# UNITED STATES PATENT AND TRADEMARK OFFICE

APPLICATION NO.	FILING DATE	FIRST NAMED INVENTOR	ATTORNEY DOCKET NO.	CONFIRMATION NO.
09/990,273	11/23/2001	Chun-Yang Hsiao	MR2707-3	2404
4586	7590	11/03/2005		
ROSENBERG, KLEIN & LEE 3458 ELLICOTT CENTER DRIVE-SUITE 101 ELLICOTT CITY, MD 21043			EXAMINER KIM, DAVID S	
			ART UNIT 2633	PAPER NUMBER

<b>Office Action Summary</b>	Application No. 09/990,273	Applicant(s) HSIAO ET AL.	
	Examiner David S. Kim	Art Unit 2633

**DETAILED ACTION****Specification**

Fig. 3

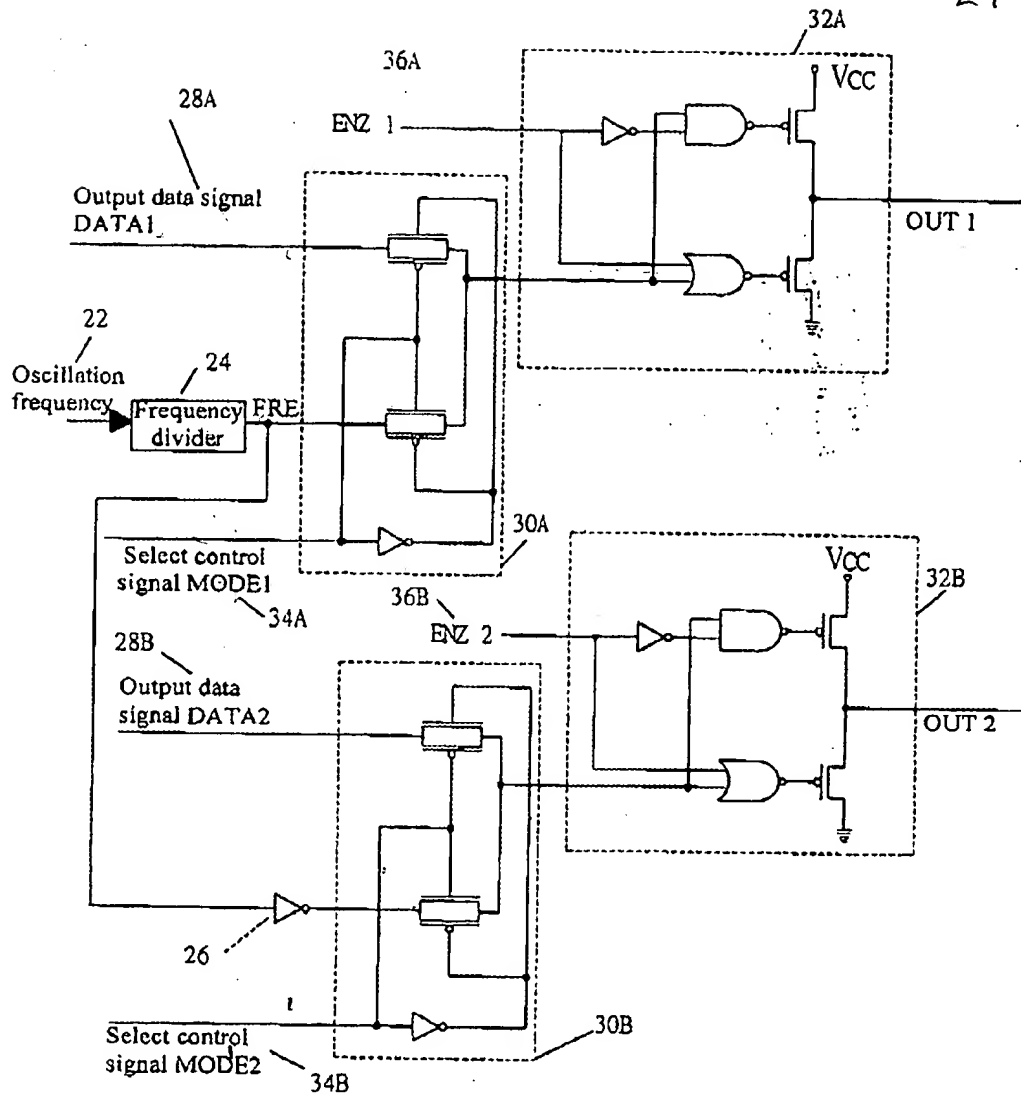
2. The replacement drawings were received on 12 May 2005. Fig. 3 is approved. However, Fig. 5 is disapproved. Fig. 5 is objected to because the middle (Fig. 5(B)) and bottom (Fig. 5(C)) diagrams do not appear to accurately reflect the specification's description of the operation of Applicant's invention.

Approved by DSK  
 27 September  
 2005

Fig. 5

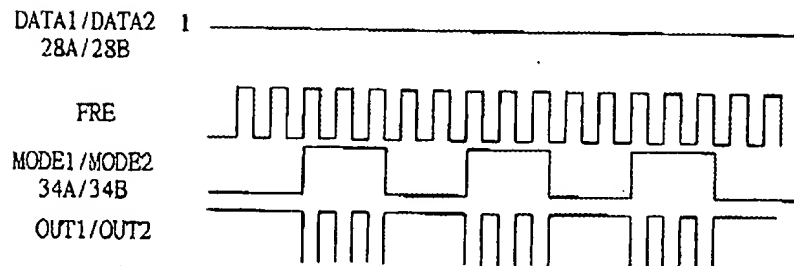
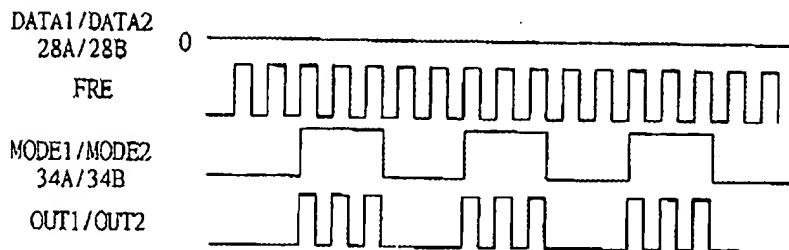
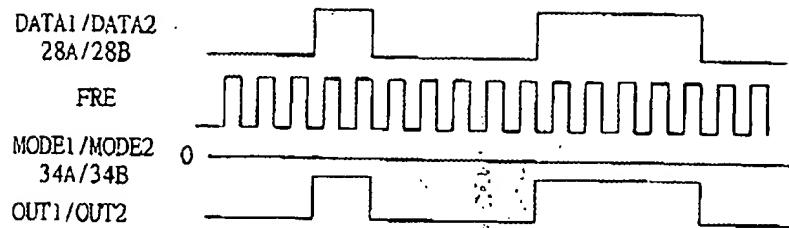
In Fig. 5(B), "OUT1/OUT2" labels a signal output that may correspond *only* to port OUT1. In particular, the first full paragraph on page 7 of the specification teaches the output of "the *inverse* of the carrier FRE." Fig. 5(B) does not show the output of this *inverse* of the carrier FRE. Rather, it appears to simply show the output of the carrier FRE, as described in relation to port OUT1 in the last paragraph of page 6 of the specification.

Similarly, in Fig. 5(C), "OUT1/OUT2" labels a signal output that may correspond *only* to port OUT2. In particular, the last paragraph of page 6 of the specification teaches the output of "a carrier FRE." Fig. 5(C) does not show the output of this carrier FRE. Rather, it appears to show the output of the *inverse* of the carrier FRE, as described in relation to port OUT2 in the first full paragraph of page 7 of the specification.

Disapproved by

3. Corrected drawing sheets in compliance with 37 CFR 1.121(d) are required in reply to the Office action to avoid abandonment of the application. Any amended replacement drawing sheet should include all of the figures appearing on the immediate prior version of the sheet, even if only one figure is being amended. The figure or figure number of an amended drawing should not be labeled as "amended." If a drawing figure is to be canceled, the appropriate figure must be removed from the replacement sheet, and where necessary, the remaining figures must be renumbered and appropriate changes made to the brief description of the several views of the drawings for consistency. Additional replacement sheets may be necessary to show the renumbering of the remaining figures. Each drawing sheet submitted after the
